## 7A Design Response to Appendix B, ABWR LRB Instrumentation and Controls

The NRC requested considerable additional information specific to this equipment in Appendix B. The NRC requests, along with responses as revised, are provided in this appendix to Chapter 7.

Figure 7A-2 Structure for Control and Instrumentation System Design

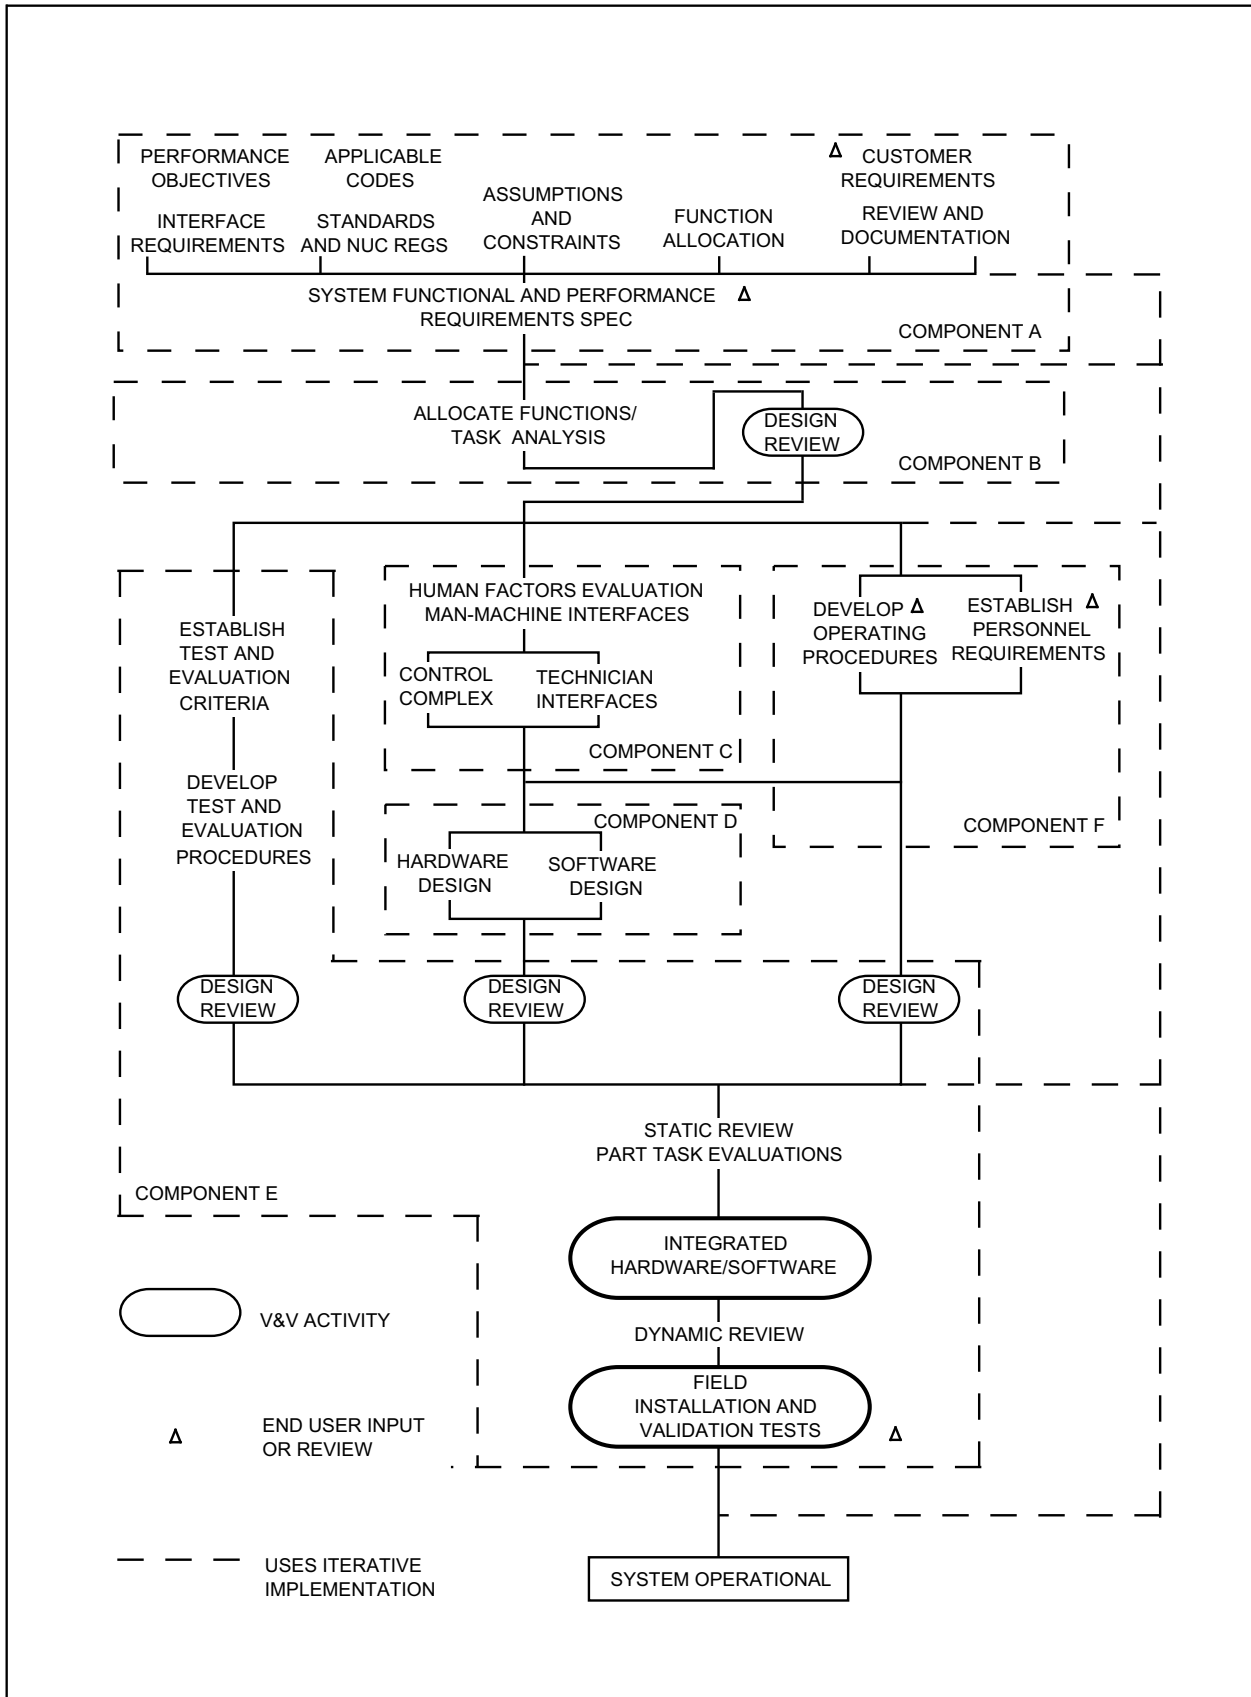
**NRC Request**—*Provide a comparison of the design with the following:*

*NRC Request—Provide a comparison of the design with the following:*

*Criteria and guidelines stated in ANSI/IEEE-ANS-7.4.3.2, as endorsed by Regulatory Guide 1.152, have been used as a basis for design procedures established for programmable digital equipment.*

*A structured, engineered approach to the development of both hardware and software is implemented to assure that the design proceeds along the lines of the requirement specifications and has traceable documentation.*

*Verification and validation (V&V) includes the establishment of test and evaluation criteria, the development of test and evaluation procedures, the testing of the integrated hardware and software, and the installation of the hardware and software in the field.*

*In accordance with the step-by-step verification process, design reviews are performed at the system functional and performance requirements specification/task analysis and allocation of functions level, the hardware design and the software design level, the test and evaluation criteria and procedures level, and the personnel requirements and operating/maintenance plan level. Such reviews are conducted by knowledgeable and experienced system engineers, software engineers, hardware engineers, etc., who are not directly responsible for the design, but who may be from the same organization.*

*Figure 7A-2 illustrates the structure utilized for ABWR control and instrumentation system design which incorporates subject guidelines.*
